**FILE NUMBER:** PLN24-017  
**SUBJECT:** Design Review and Grading Approval of an 8,000 square foot (s.f) single-family residence, a 1,198.75 s.f. ADU, a 499 s.f. JADU with small-scale agricultural processing and small-scale agricultural sales on Lot A.  
**SITE LOCATION:** 2425 Old Calaveras Blvd., Milpitas (Lot A of APN: 029-34-004)

**PLANNING OFFICE**

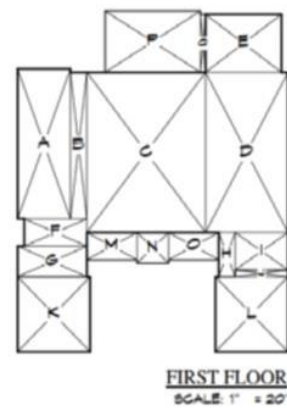
6. Identify and label existing grade on Sheet A.4. Clarify if the lower portion of the residence will be underground as the “East Elevation” on Sheet A.4 show a portion of the residence below the “upper grade.”

Response: We have updated the plans to reflect grade lines on elevations and sections (A03-A05).

The lower level is split into Level 1 and Level 1.5 due to changes in grade, with a top level labeled as Level 2.
